Assessment of Environmental Effects

43 Cargill Street, Dunedin

Version with Updates Resulting from Further Information Request Including FIR Response

Appendix 5: Response to Further Information Request

Table 6: AEE for Height and Height Plan Angle Breaches Pursuant to Both Plans

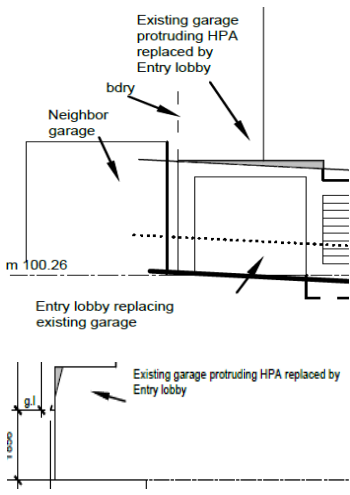
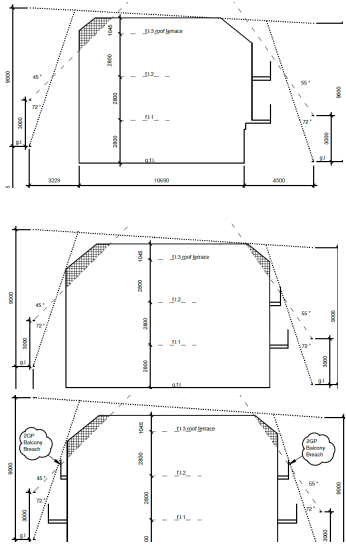
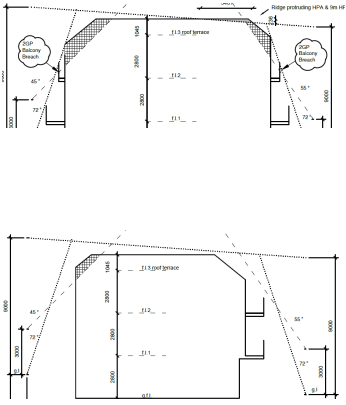
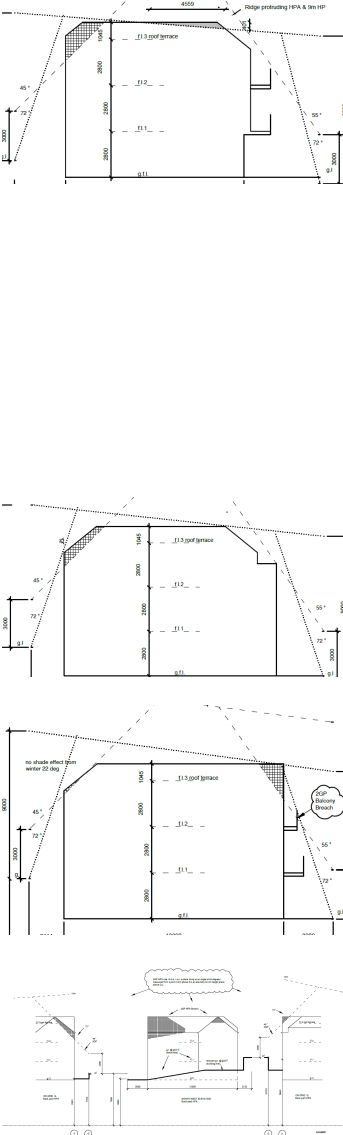
Part of Building	Plan Breached & Breach	Assessment of Environmental Effect
Fence	2006 District Plan & 2GP 	The fence breaches the 2m maximum height requirement for fences specified by both the 2006 district plan and the 2GP. At most, the height of the fence will be 2.540m grading back to 2m over the distance of the louvre filled part of the fence and most of the opening to the basement garage area. A pedestrian will experience an increasing sense of bulk as they walk, past the site. However, this experience will be in the context of views of adjacent multi-storeyed buildings and mall buildings at the bottom of the street when walking downhill; and views of multi-storeyed buildings in the distance when walking past uphill. The experience of viewers travelling past in vehicles will be very brief and again will be in context of multi-storeyed buildings in the view. The additional height of the fence is less than the height of existing vegetation on the boundary of the site and, therefore, will have less of an effect than presently experienced with respect to shading. Breach will have a less than minor effect on the environment.

Entry Lobby	2006 District Plan 	The entry lobby is to be built within the footprint (including height) of the existing garage which will be demolished. As such the effects of lobby are effects which are already present in the existing environment and form part of the permitted baseline. Breach will have no adverse effect on the environment.

Part of Building	Plan Breached & Breach	Assessment of Environmental Effect
Basement	2006 District Plan 	Although technically a breach of the height plane angle in the 2006 district plan, there will be a negligible effect arising from this breach due to the following factors: - The basement garage outside wall and rooftop will be screened from Cargill Street due to the fence on the boundary. - There is an accessway on the adjoining property on the downhill side of the site with retaining walls and landscaping continuing to screen views into the site.
Unit 1	2006 District Plan 	The gable of unit 1 breaches the maximum height whilst it and the balcony facing the street frontage also breach the height plane angle required by the 2006 district plan. These are not breaches pursuant to the 2GP. The balconies will be enclosed by glass balustrades which will minimise the bulk of the balconies on the building. The gable end with small window will provide visual amenity and relief in the design. The effects of the breaches will be less than minor.

Unit 2	2GP 	The 2GP height plane angle provisions are under appeal making assessment of the effects of the breaches of those provisions difficult due to uncertainty over content of the provision. As such, the effect of these breaches are deemed no more than minor particularly given the topography of the site and surrounding properties.
Unit 3	2006 District Plan and 2GP 	A small section of the upper part of Unit 3 will breach the 2006 district plan height plane angle (see solid gray shaded area). This breach is assessed as less than minor. The 2GP height plane angle provisions are under appeal making assessment of the effects of the breaches of those provisions difficult due to uncertainty over content of the provision. As such, the effect of these breaches are deemed no more than minor particularly given the topography of the site and surrounding properties.

Part of Building	Plan Breached & Breach	Assessment of Environmental Effect
Unit 4	2006 District Plan and 2GP  The diagrams illustrate the building's height and plan breaches. The top three diagrams show cross-sections of a building with height markers (11.1, 11.2, 11.3) and angles (45°, 75°, 65°). The bottom diagram shows a plan view with a '2GP Density Breach' callout.	A small section of the upper part of Unit 4 will breach the 2006 district plan height plane angle (see solid shaded gray area). This breach is assessed as less than minor. The 2GP height plane angle provisions are under appeal making assessment of the effects of the breaches of those provisions difficult due to uncertainty over content of the provision. As such, the effect of these breaches are deemed no more than minor particularly given the topography of the site and surrounding properties.

Attachment 3: Further Documentation: 3a: Shading Diagram

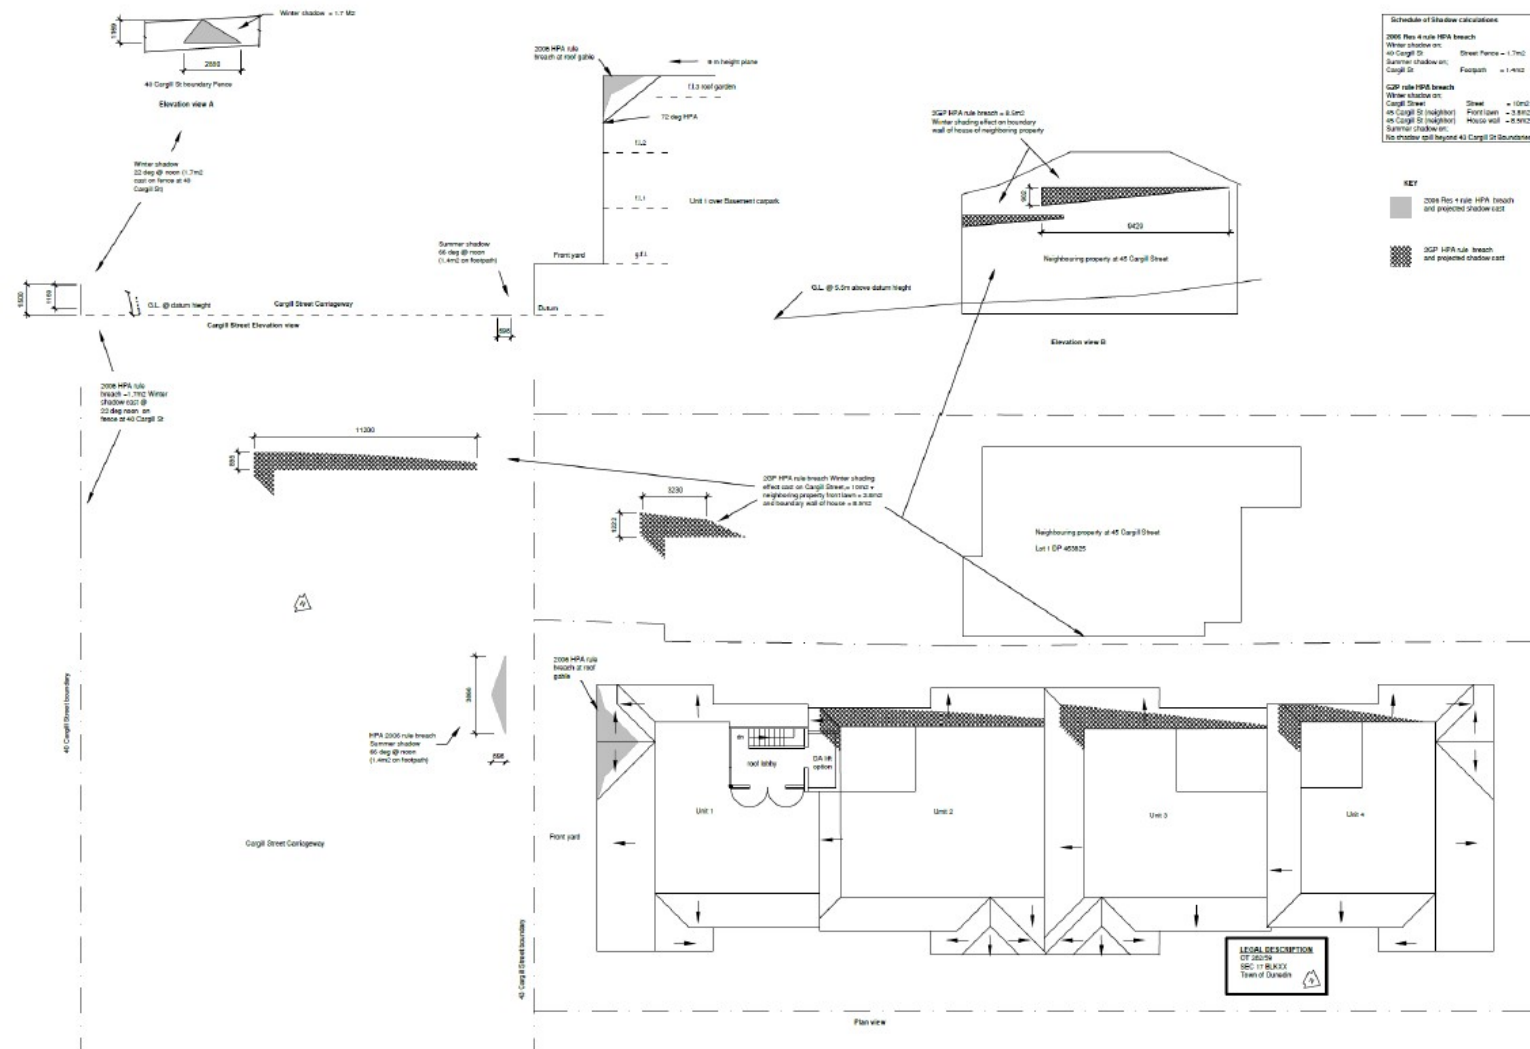
- There is little in the way of analysis of the effects of additional shading on adjacent dwellings due to the 2GP height plane breaches (no shade diagrams);*

The applicant has undertaken an analysis of shading. A shading diagram of breaches of both the 2006 district plan and the 2GP is included at Attachment 3b of this document. The analysis shows that there are shading effects on both the adjacent property at 45 Cargill Street and Cargill Street itself, but that because the height and HPA breaches are minor, the shading effects are relatively minor and less than existing shading caused by a block of evergreen trees on the site which will be removed prior to development.

Attachment 3: Further Documentation: 3b: Elevation through Grid A Showing Fence Detailing

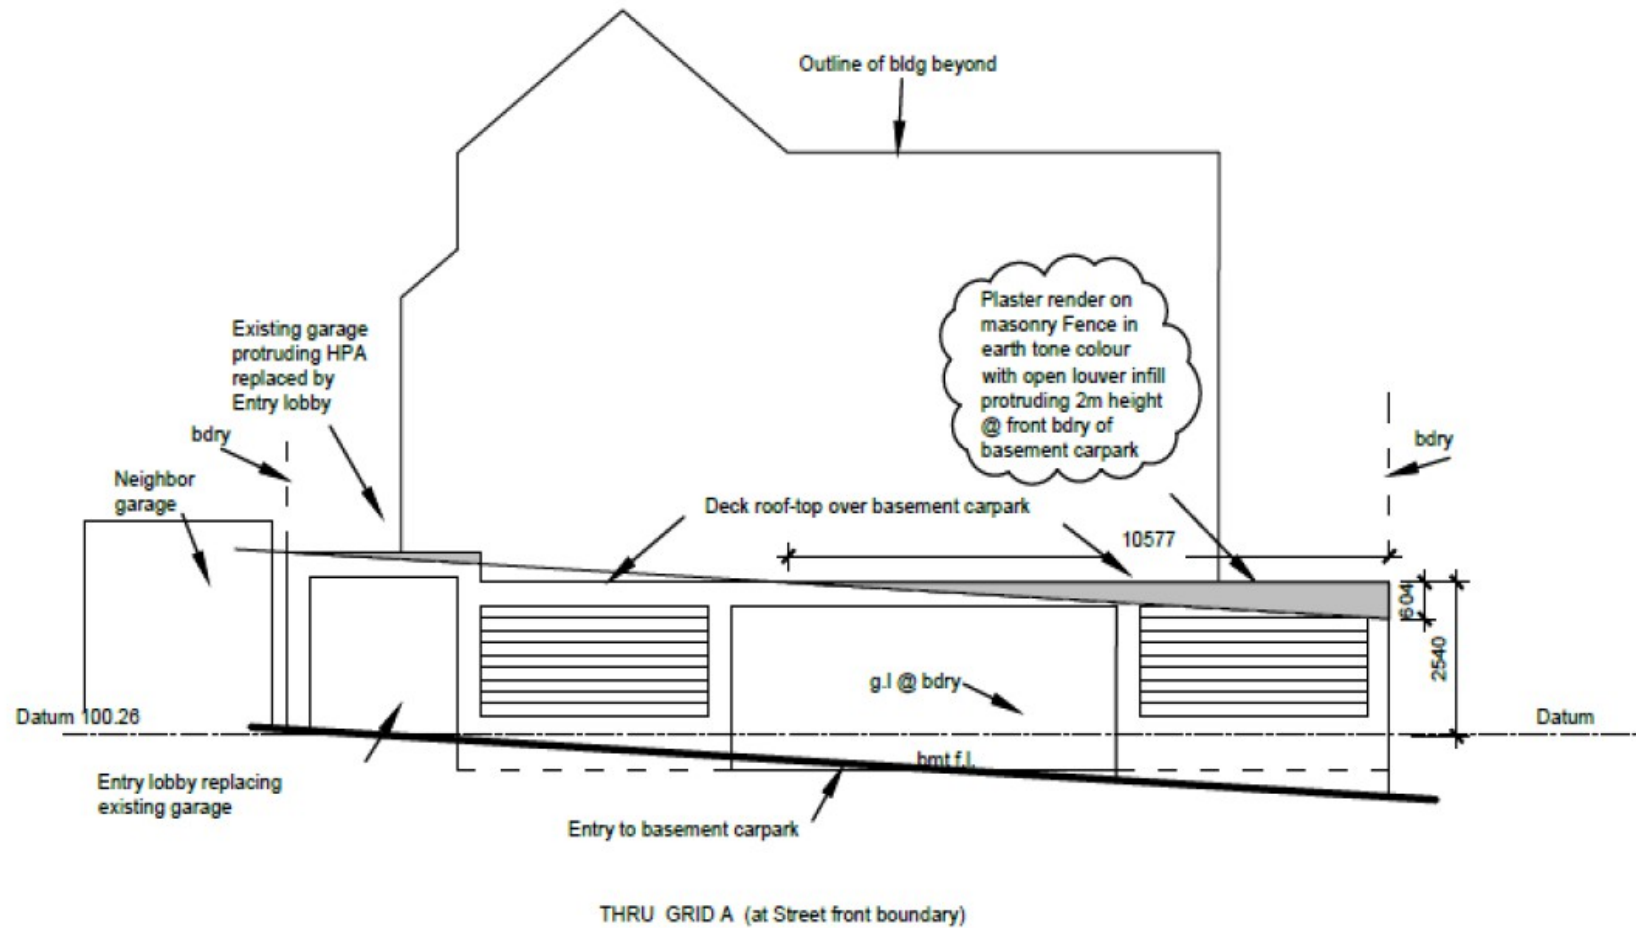
Plan	Rule	Comment by DCC Consultant Planner	Discussion
2006 Discretionary Plan	8.6.1(vi)	<i>The "fence" must also infringe the 2m height rule along some of the eastern side boundary.</i>	This rule pertains to retaining walls being erected on yards which is permitted provided that building consent has been granted. Building consent will not be sought for the proposal until after resource consent is obtained. The application for building consent will include retaining walls within yards.

Attachment 3: Further Documentation: 3c: Amended Floor Plans for Units 1 and 2 showing Windows in Front Elevation

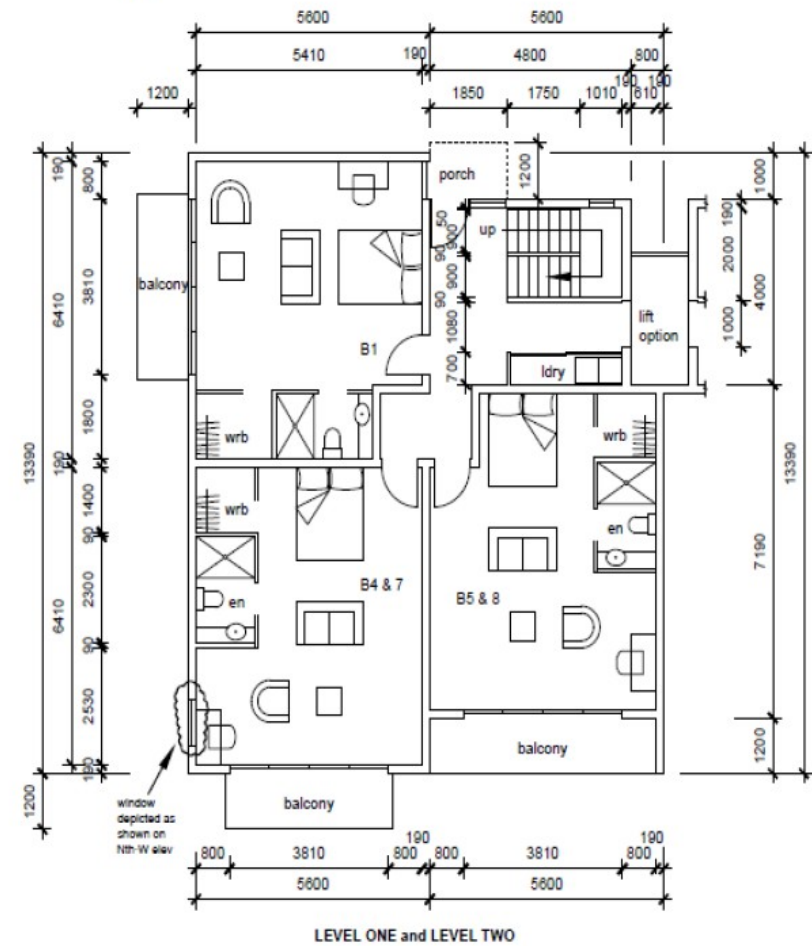
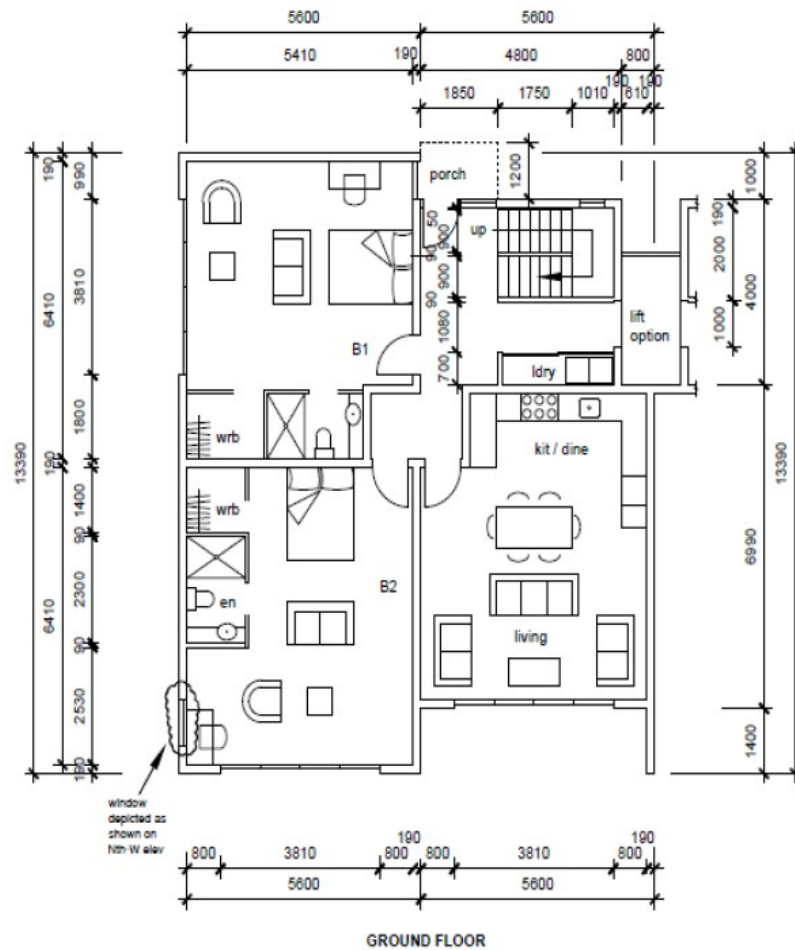
- Copies of the elevations and floor plans are difficult to read;...*
- The front façade includes a large expanse of blank wall. Consideration could be given to additional windows and/or varying the appearance of the elevation in terms of its depth and modulation, finish material, colour or texture; - also, although the front façade shows two small windows, these are not shown in the floor plans.*

The updated AEE includes the revised floor plan which now shows the front facade windows (Units 1 and 2) previously included in the elevations but not the floor plan.
